SUBJECT: Philips HADCO comments on Revised Draft Criteria of Outdoor Area and Parking Garage SSL Luminaires.

Figure 1. Competitor fixture performance per the FTE calculator.

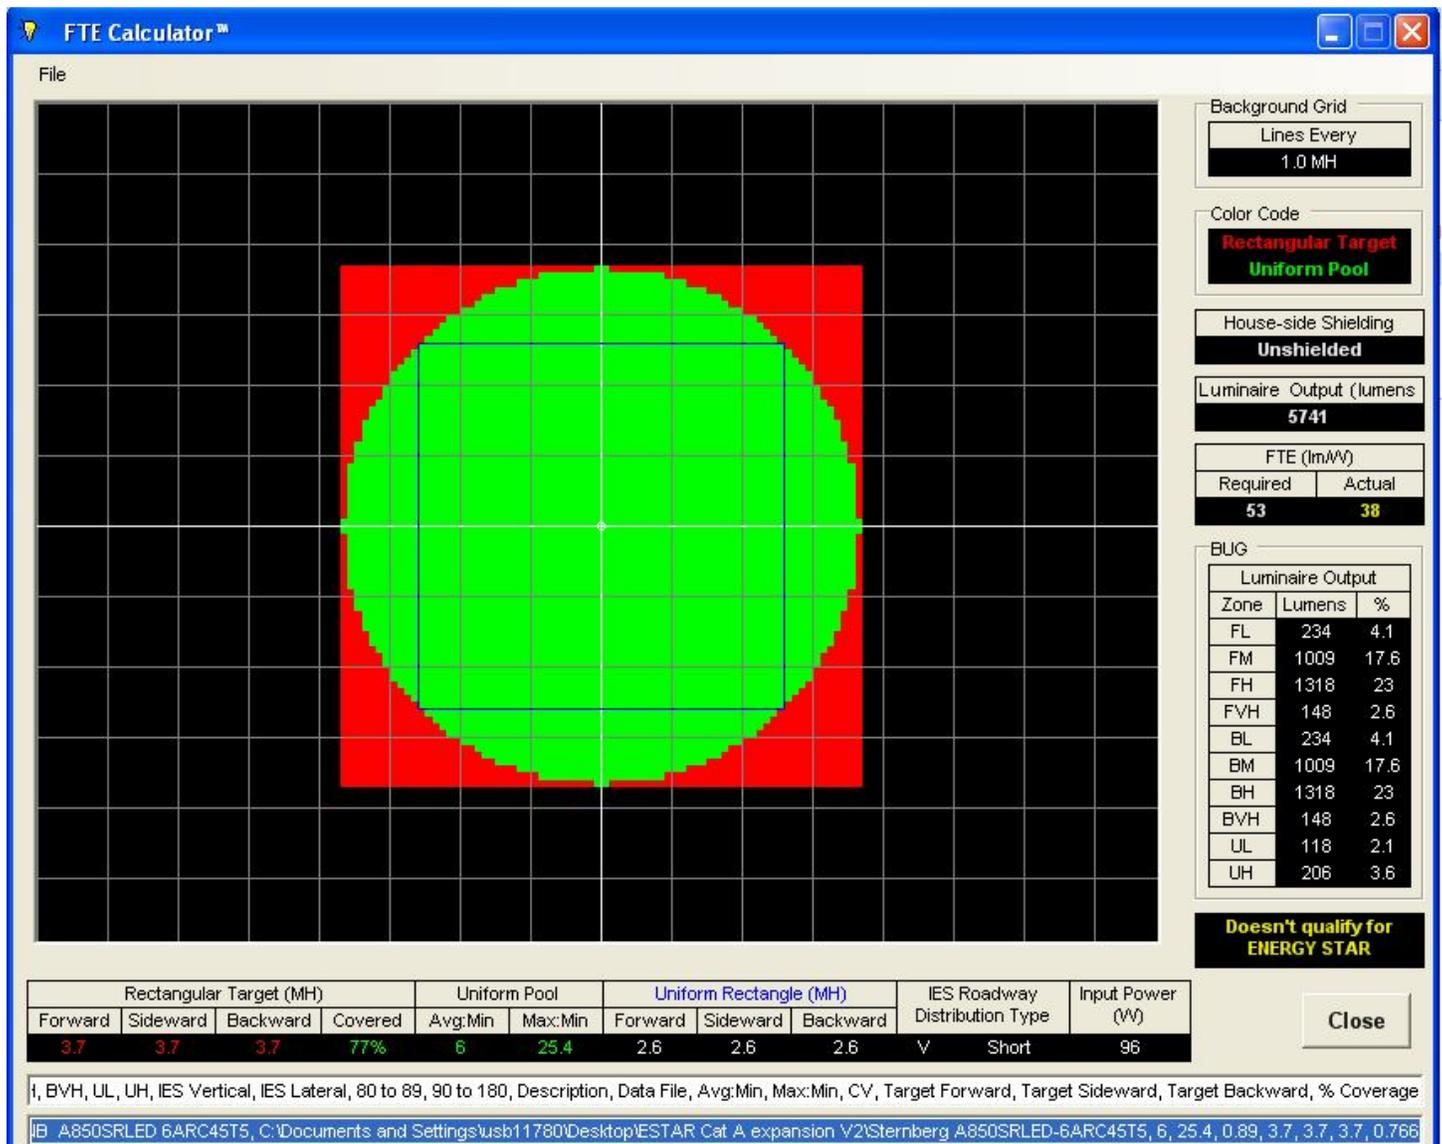
Even though the competitor fixture has higher LPW per the FTE calculator, all three fixtures have comparable “traditional” LPW values – and the HADCO fixture achieves this while consuming less input power and with less lumen output.

Per the .ies file, it seems that the competitor’s fixture was not tested per LM-79-08 and it definitely was not tested by a DOE-approved independent test lab. It does appear to have been tested using absolute photometry. It is curious that this fixture performs better per this FTE calculator even though it was not tested per LM-79-08 considering that LM-79-08 is required for SSL ENERGY STAR.

The HADCO fixtures also cover larger areas more effectively. You would need 1.5 – 2 times as many competitor fixtures to cover the same area illuminated by one HADCO fixture. The FTE metric only evaluates a single fixture at a time when the vast majority of outdoor lighting applications require multiple fixtures, which is why applications tools such as AGi32 are typically used for layouts.

Therefore, in this example the FTE metric penalizes a fixture with a more effective optical design that consumes less power and covers a greater area. This contradicts the objective of promoting energy efficient lighting products.

Figure 3. Philips HADCO fixture performance per the FTE calculator. This is the clear composite roof version.

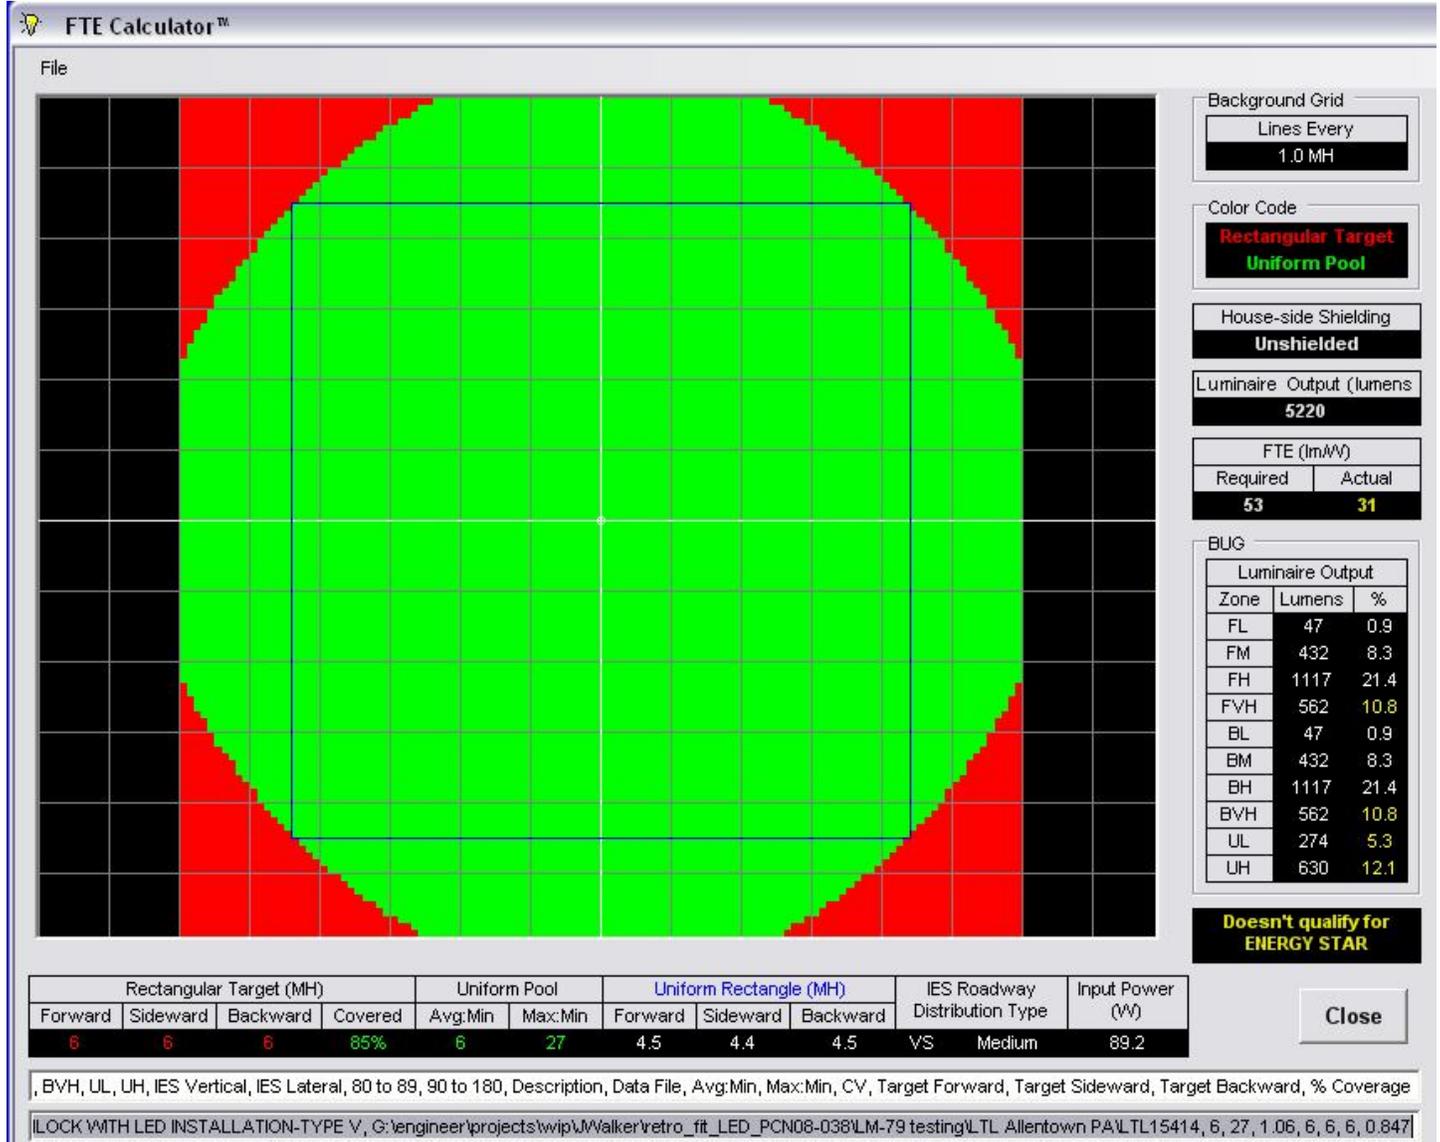
The HADCO clear roof photometric (.ies) file was generated by a DOE-approved independent test lab per LM-79-08; the HADCO solid roof .ies file was generated in HADCO’s environmentally controlled lab following LM-79-08 procedures. Our lab is compliant to ANSI (American National Standards Institute) and NIST (National Institute of Standards and Technology) standards and it undergoes annual review. The lab is recognized to participate in UL’s Client Test Data Program and ETL’s Satellite Program.
